Item ID: 646.3001 Accept ***N900040100*** Setup Start ***NS1***
Revision ID: Stop ***NS2***
Item Name: Lower Cable Cutter Assembly
Start Date: 9/11/2017 Start Qty: 4.00 ***4*** Cust Item ID:
Required Date: 9/22/2017 Req'd Qty: 4.00 ***4*** Customer:
Reference:

ENGINEERING CHANGE NOTICE NO.		02195		SHEET 1 OF 4	
DWG NO.	646.3000	REV: N/C	PREPARED BY	S. HUFF	DATE: 01/05/09
DWG TITLE:		LOWER CUTTER ASSY			
APPROVED BY:	ENGR <i>[Signature]</i>	MFG <i>[Signature]</i>	QC <i>[Signature]</i>	EFF:	NEXT ORDER
TRANSACTION CODES (TC): A-ADD C-CREATE R-REVISE D-DELETE		REASON: REMOVED RIVETS IN FAVOR OF ADDITIONAL SCREWS

SHOP COPY
RETURN TO
ENGINEERING
UNCONTROLLED COPY
SUBJECT TO AMENDMENT
WITHOUT NOTICE
WORK ORDER
NO. 166082 MJS
1709-11

SHEET 1, ZONE D5, IS:

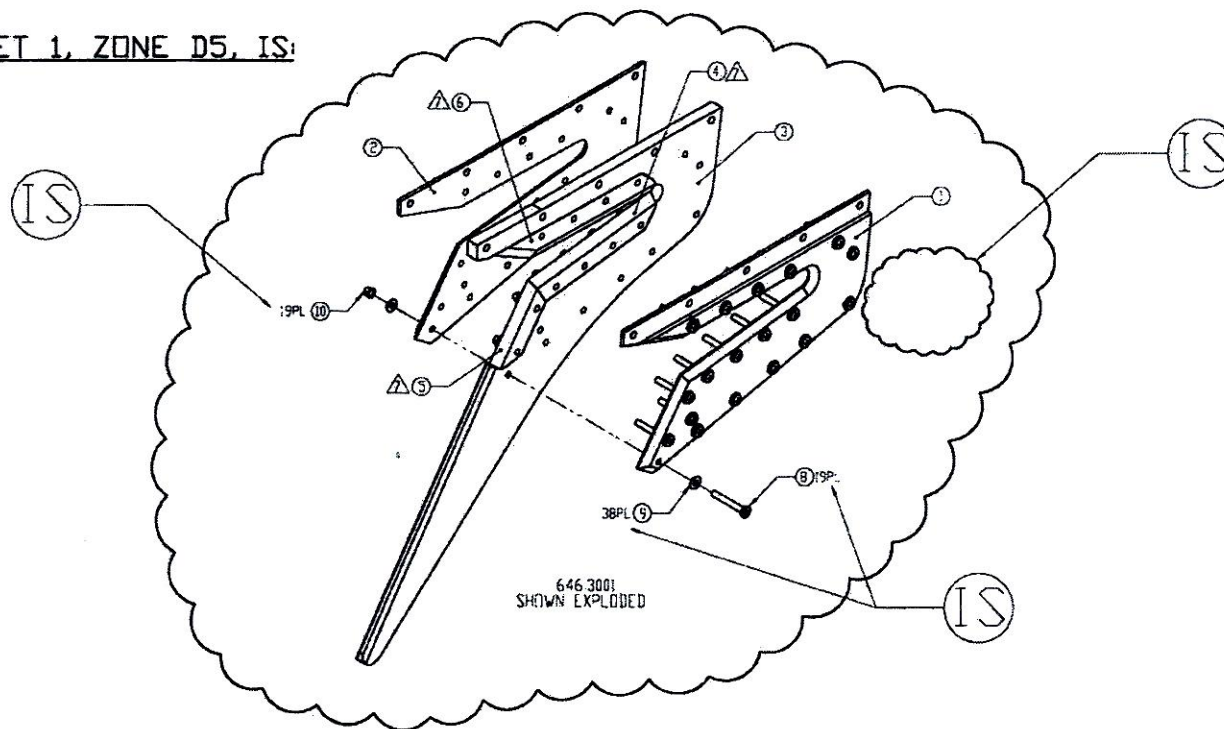
10	R	601.1541		19	LOCKNUT	MS21042L08
9	R	601.2764		38	WASHER	NAS1149FN832P
8	R	601.2765		19	SCREW	MS27039-0819
7	D	601.2766		2	RIVET	MS20470AD5-18
				.3001		
F/N	TC	PART NUMBER	QTY	DESCRIPTION	MATERIAL/SPECIFICATION	
DOCUMENTS EFFECTED:						CHANGE CATEGORY
						DER REVIEW REQUIRED
						MAJOR MINOR
						YES NO
